Access Compliance Report

Public Rights-of-Way

(Curb Ramps)

Intersection ID: 3441	Main Street: KATELYN_DR	Cross Street: SILVERMERE_WY	Location: SW
ADA ID: D7305E741BF0	Ramp Type: Directional1	Initial Pass/Fail: Fail	Overall Compliance: No
Severity Score: 12.5			
Codes/Mitigation Info/Possible Solution		Field Measurements/Component Compliance

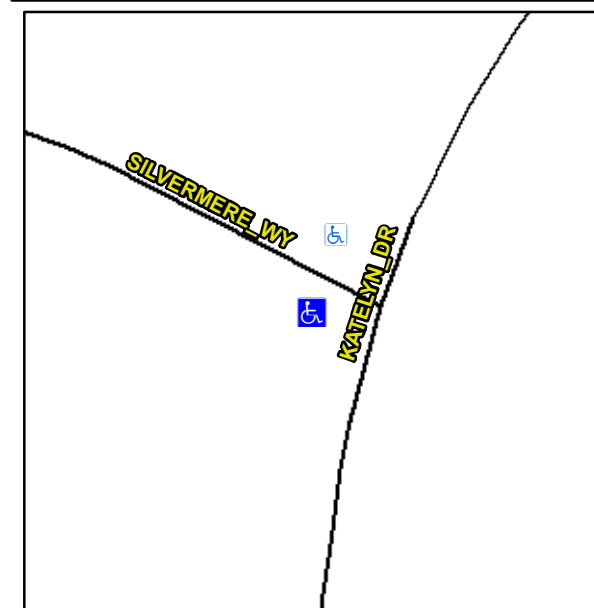
R304.2.2

Compliance	Description	Data	Compliance	Description	Data
N/A	Ramp Length (in)	80.0	N/A	Grade Break?	N/A
Yes	Ramp Width (in)	49.0	N/A	Grade Break Slope (%)	0.0
No	Ramp Slope (%)	8.6	N/A	Grade Break XSlope (%)	0.0
Yes	Ramp XSlope (%)	0.5			
N/A	Flare Type LT	N/A	N/A	Flare Type RT	N/A
N/A	Flare Slope LT (%)	N/A	N/A	Flare Slope RT (%)	0.0
N/A	Flare Traversable LT?	N/A	N/A	Flare Traversable RT?	N/A
N/A	Landing Length (in)	0.0	N/A	DWS Provided?	N/A
N/A	Landing Width (in)	0.0	N/A	DWS Contrast?	N/A
N/A	Landing Slope (%)	0.0	N/A	DWS Length (in)	N/A
N/A	Landing X Slope (%)	0.0	N/A	DWS Full Width?	N/A
N/A	Landing Curb? (Y/N)	N/A	N/A	DWS Offset LT (in)	N/A
N/A	Shared Landing?	N/A	N/A	DWS Offset RT (in)	N/A
N/A	Gutter Ponding?	0.0	N/A	Gutter Slope (%)	N/A
N/A	Gutter Lip Ht (in)	0.0	N/A	Gutter X Slope (%)	N/A
N/A	Painted X Walk1?	No		Road Slope (%)	0.7
	X Walk 1 Direction	To N		Road X Slope (%)	4.0
	X Walk 1 Width (in)	N/A		Clear Space?	N/A

Remove & Replace Entire Ramp.
